# SERVICE PARTS LIST

PAGE 1 OF 2 **BULLETIN NO.** 54-38-1625

**31-50-1752 Motor Housing Kit** incorporates changes to the shielding of the armature pinion and commutator ball bearings along with the retaining of the pinion ball bearing into the gearcase assembly of 7"/ 9" 15Amp Sander / Grinders – 6080-20, 6081-20, 6082-20, 6086-20, 6088-20 and 6089-20.

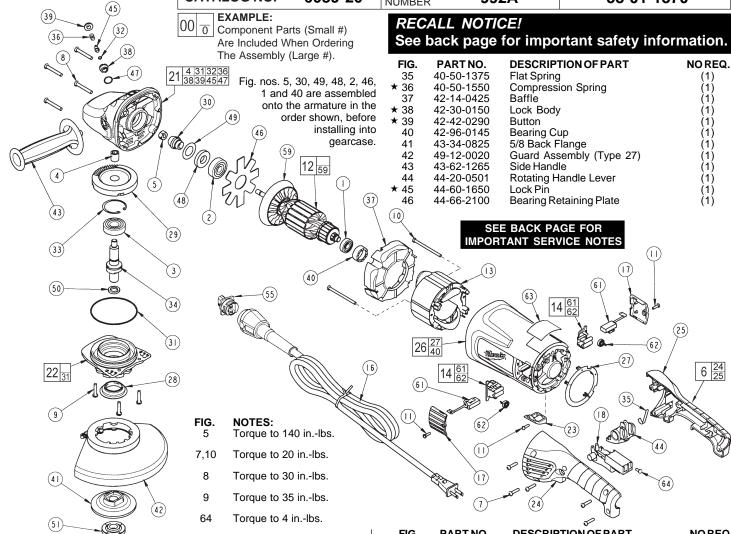
Additionally, a change has been made to the motor housing and wiring of the tool. The ATF field coil is now 'hard-wired' with four [4] new leadwire assemblies, see **Wiring Instruction 58-01-1371**. Add 'X' Grease, 49-08-5000 to mag-mate field terminals as need.

APPLY 40-08-SD00 TYPE "V DISLECTRIC GREASE TO MAC MAIT! CONNECTION OF FIELD AS SHOWN.

FILL CAVITY OF MACMANTE PROCEST, DO NOT DAYS FILL AND ALLOW GREASE TO EXTEND PAST EDGES OF CAVITY.

IT 19 PERMISSIBLE TO HAVE GREASE IN THUS AREA.

Caution! Do Not overfill the cavity, excess grease can cause a build up of dust / dirt and result in a possible 'shorting-out' or burning at the connection.

Service Note - 'check for slip fit' - mounting of 02-04-1680 Ball Bearing to the armature shaft may require removal of a 0.0001" - 0.0002" from the O.D. of the armature pinion end ball bearing journal it is recommended to use emery cloth and armature lathe to lightly sand, for a few seconds, removing the material necessary for the pinion shaft to be a 'slip fit through the pinion ball bearing' as it is being held in place in the GearCase by the 44-86-0040 Bearing Retainer.
